## MEMORANDUM

**MFG PROJECT: 180734**

**TO:** Dr. A. K. Ibrahim, U.S. Nuclear Regulatory Commission

**SUBJECT:** Sequoyah Fuels Corporation Site, Shear Wave Velocities

TITLE	
DISPOSAL CELL GEOLOGIC CROSS SECTIONS	
PROJECT	100734
DATE	MARCH 2005
SCALE	AS SHOWN
DRAWING	GEO-XSEC-2.dwg
REVISION	14

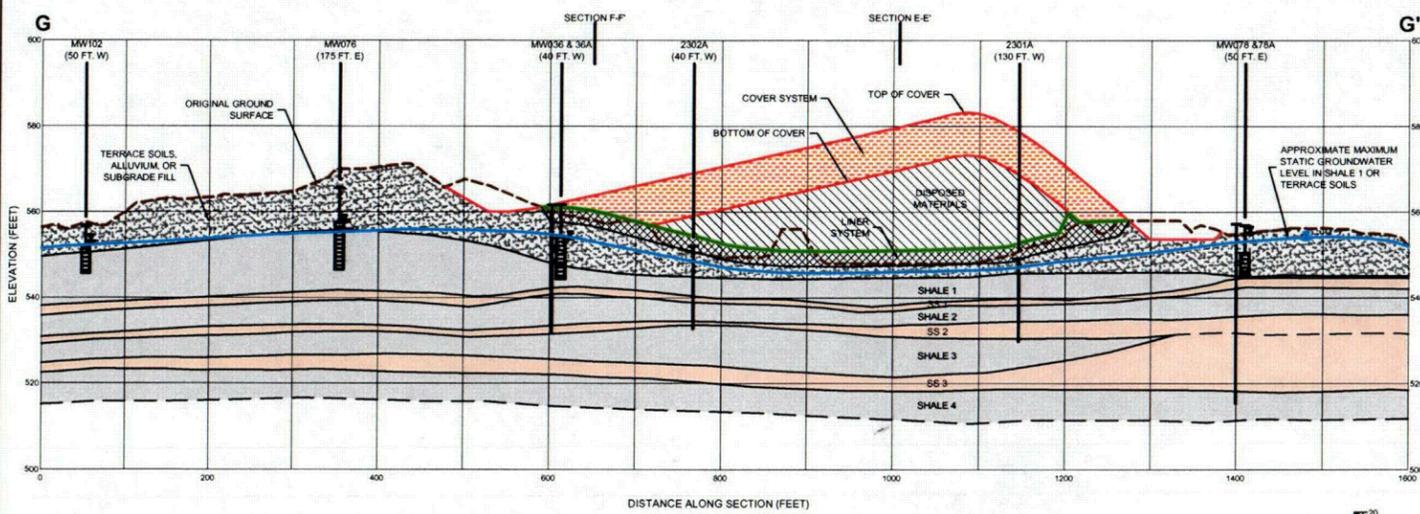
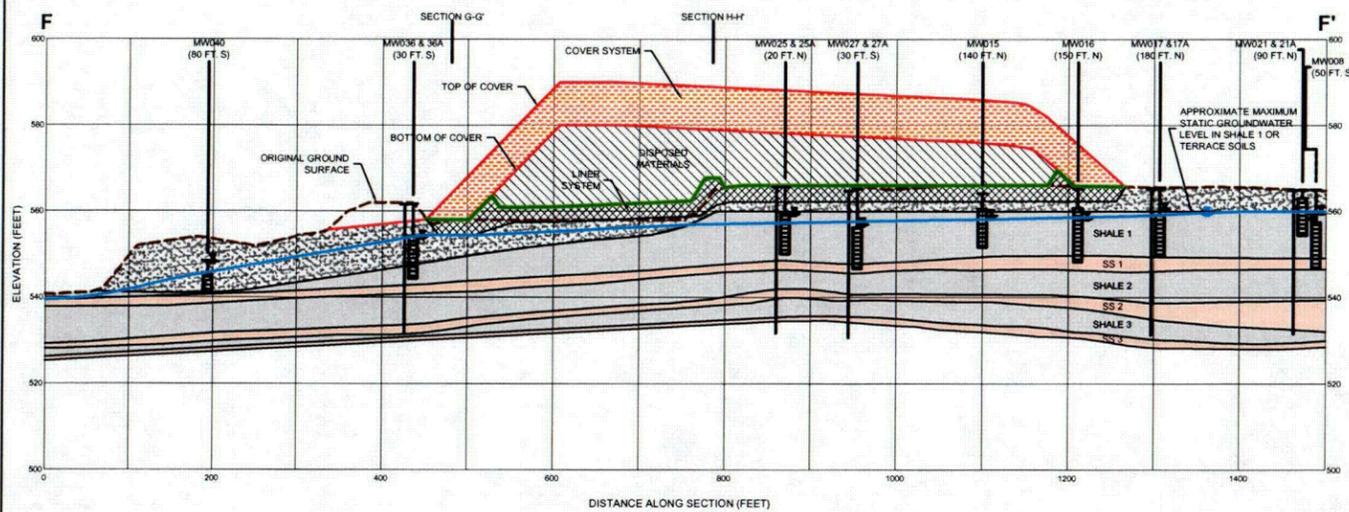
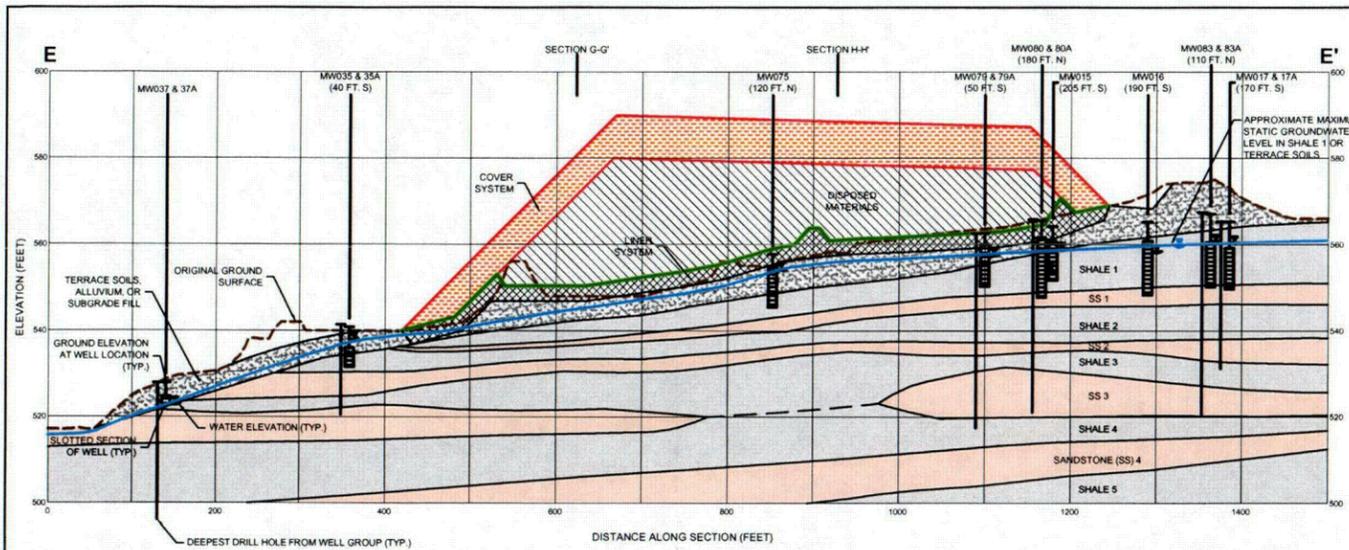
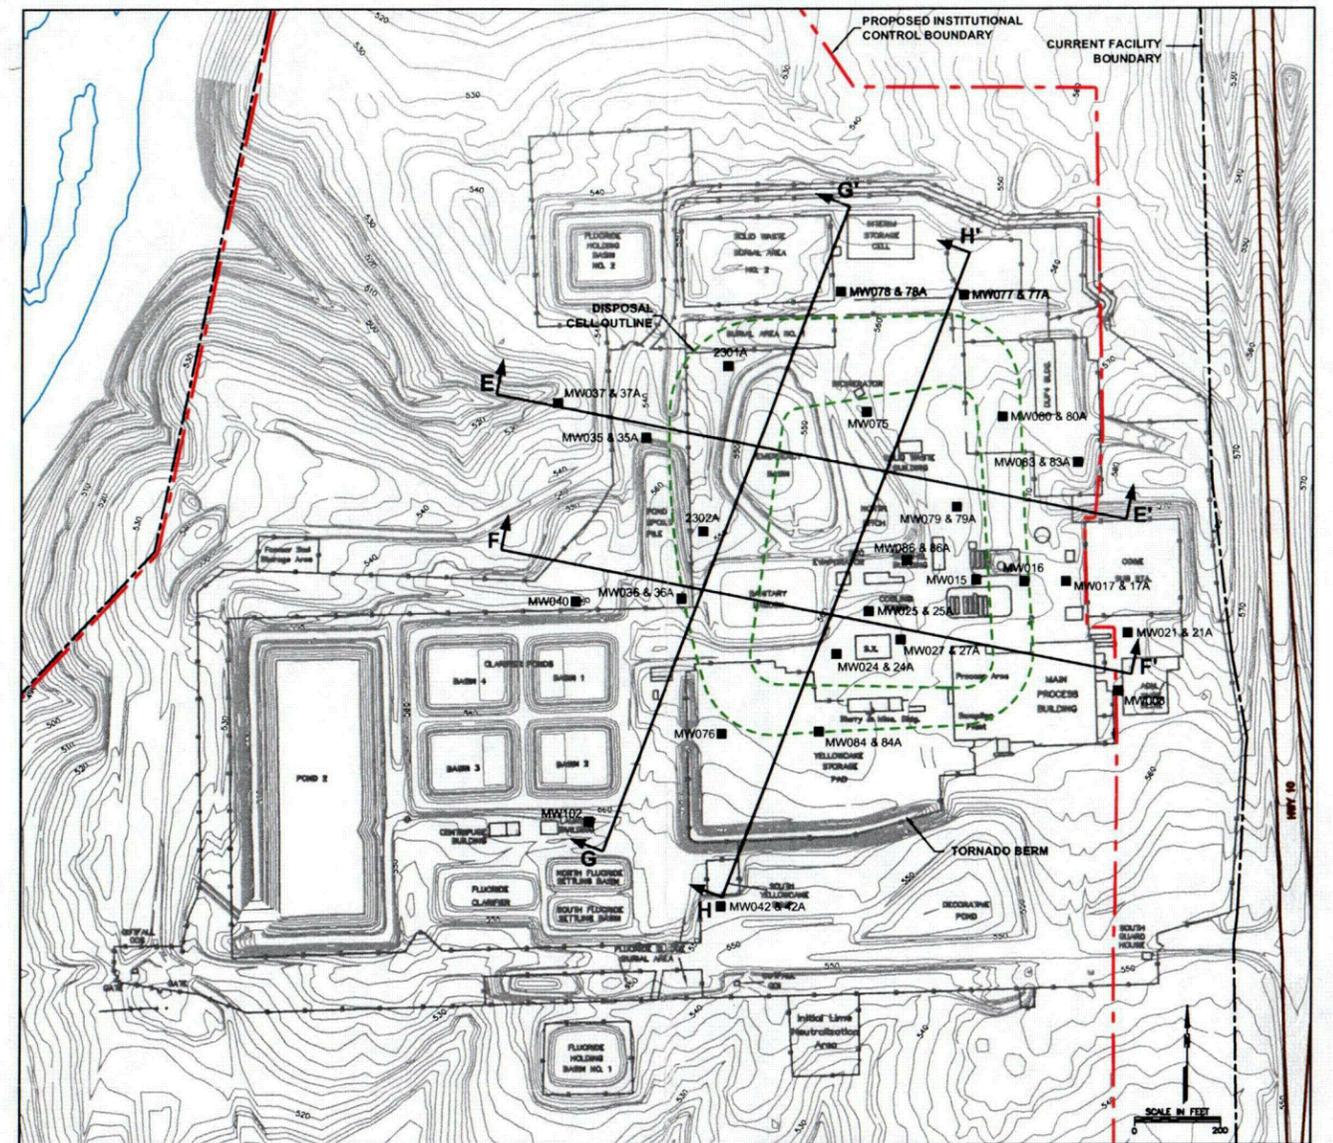
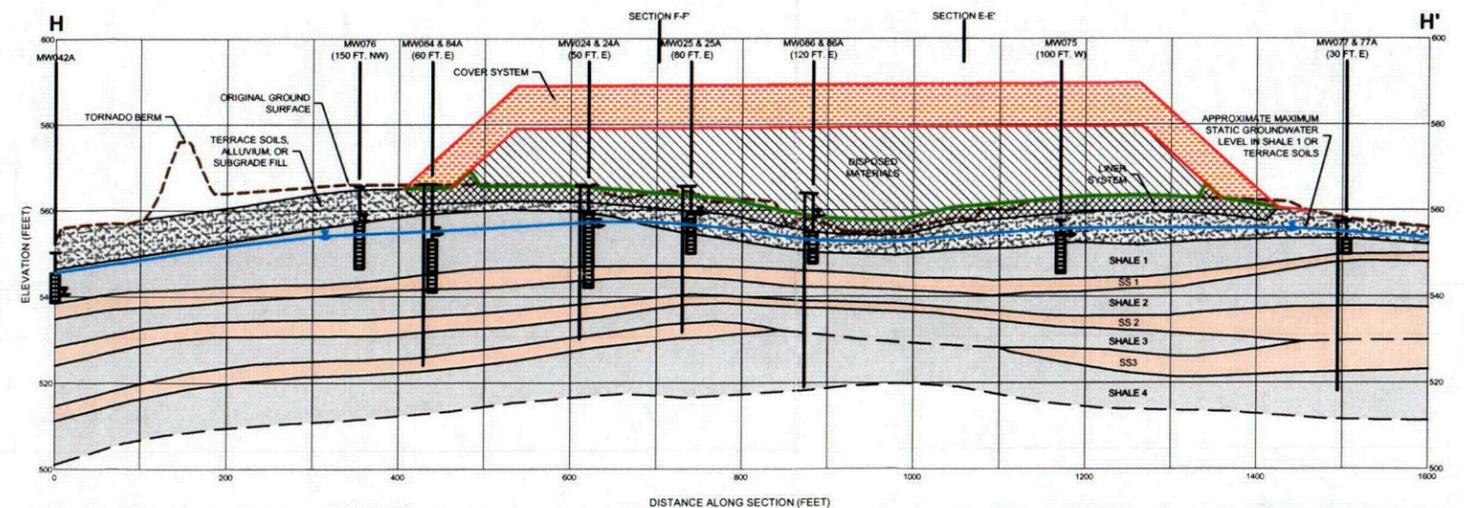
Request for Additional Information (RAI) Issue S8 asked for justification for not accounting for local soil amplification at the disposal site when calculating the design seismic ground motion. In the response to that RAI, MFG (MFG, 2004) explained that significant thicknesses of unconsolidated soils are not present in the disposal cell area. In addition, site soil cleanup work will remove most of the remaining terrace soils or other surface soils in the disposal cell footprint area. Therefore, no local soil amplification is anticipated for these foundation conditions. This is consistent with seismic analysis methods (such as Spudich and others, 1999) where soils less than 5 meters thick are not evaluated for amplification.

The disposal cell will be constructed on sandstone and siltstone units of the Pennsylvanian Atoka Formation. Geologic cross sections of the site area with these units and their geologic descriptions are provided in MFG (2002). In addition, a copy of Drawing 14 from the Specifications and Drawings (Reclamation Plan, Attachment A) is attached to this memo. The upper 20 to 30 feet of the Atoka formation are weathered.

As shown in Drawing 14, terrace deposits estimated to be a maximum of 12 feet thick are overlying the Atoka Formation in the disposal cell footprint area. Boring logs in the area (Hemphill Corporation, 1980 and Roberts/Schornick and Associates, Inc, 1990) describe the terrace deposits as varying from gravelly silty clay, silty clay, to clay. Consistency is soft to firm with an average dry unit weight of approximately 105 pcf. The majority of these soils will be excavated during subsoil clean up, then placed and compacted within the disposal cell.

The disposal cell footprint is likely to have an irregular surface from areas that have been excavated during subsoil cleanup. Subgrade fill will be used in excavated areas of the disposal cell footprint to meet desired grades and elevations for the disposal cell foundation (shown on the Drawing 14). Depths of

subgrade fill will be sufficient to maintain the base of the compacted clay liner of the disposal cell a minimum of three feet above the maximum observed groundwater level. Subgrade fill will consist of off-site granular materials, or soils and weathered sedimentary rock from approved on-site excavation areas. Subgrade fill will be compacted in 12-inch lifts. The depths of compacted granular fill versus remaining in-place terrace materials is unknown at this time. However, the total depth of unconsolidated soil material underlying the disposal cell will vary from negligible amounts to a maximum of ten feet, with an average depth of five feet.
